WILLIAM POPE FAMILY DIVISION SUBDIVISION

APPLICATION NUMBER 7 DATE May 7, 2015

DETAIL SITE PLAN

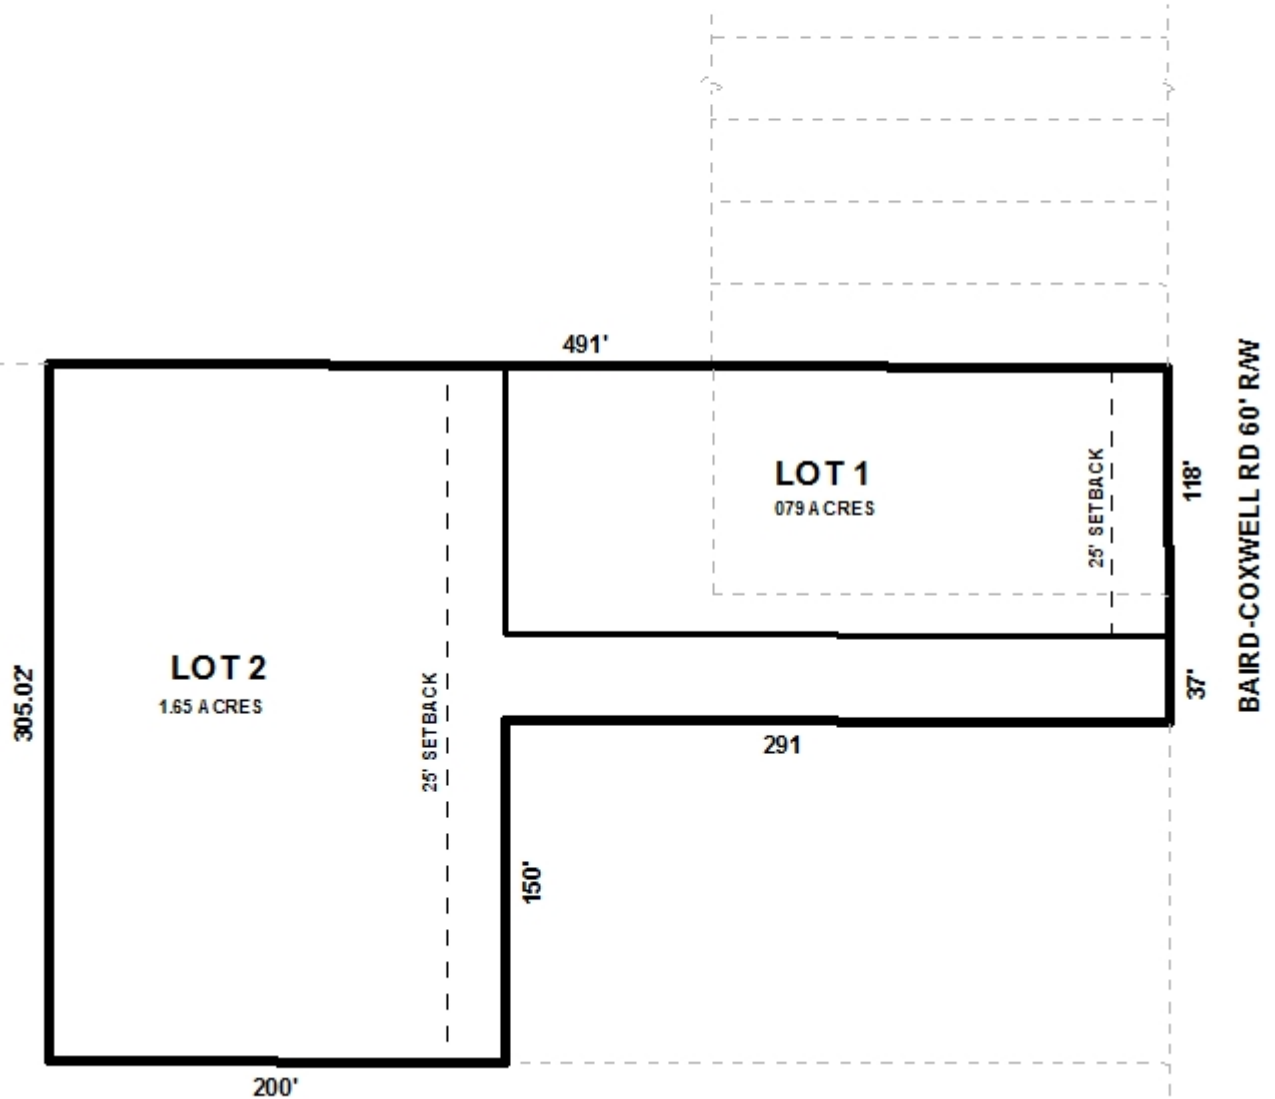
It should be pointed out that the configuration of William Pope Subdivision and First Addition exists with 50’ between them to allow for construction of a road for future (now) subdivision of the future development area. The proposed configuration reduces that 50’ to 37’± to access the proposed new lot. This limits the ability for future resubdivision of the future development area.

In accordance with the Subdivision Regulations, the proposed lots exceed the minimum lot size requirements and the 25’ minimum building setback line is depicted on the preliminary plat. Both should be retained on the Final Plat; however, the 25’ minimum building setback should be depicted as a box where the “pole” meets the “flag” portion of the lot, if approved.

The proposed lot fronts Baird Coxwell Road, a minor street without curb or gutter. The existing 60' right-of-way width is compliant and as a result, no dedication is needed. It appears that both proposed lots have existing curb-cuts to Baird Coxwell Road. As such, a note should be placed on the Final Plat limiting both lots to the existing curb-cuts, with any changes to the size, design and location to be approved by Mobile County Engineering and conform to AASHTO standards.

- 1) Revision of the 25' minimum building setback line for Lot 2, to be depicted as a box where the "flag" meets the "pole" of the lot, and retained elsewhere;

- 2) Retention of the lot size in square feet and acres on the Final Plat;
- 3) Placement of a note on the Final Plat stating: Both lots are limited to the existing curb-cuts to Baird Coxwell Road, with any changes to the size, design and location to be approved by Mobile County Engineering and conform to AASHTO standards;
